# Rezoning Transportation Analysis

Petition Number: 2023-092

Date	Description
9-28-23	First Review (NK)
11-27-23	Second Review (JP)
1-24-24	Third Review (JP)

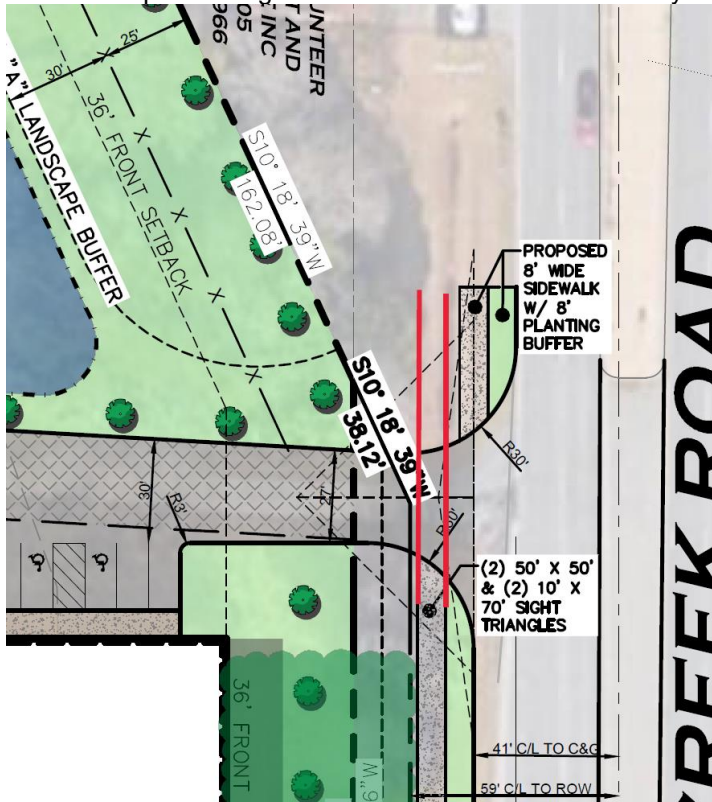
6. ~~Revise site plan to commit to extending the existing median to the intersection of the I-485 ramp and Steele Creek Road in coordination with NCDOT.~~
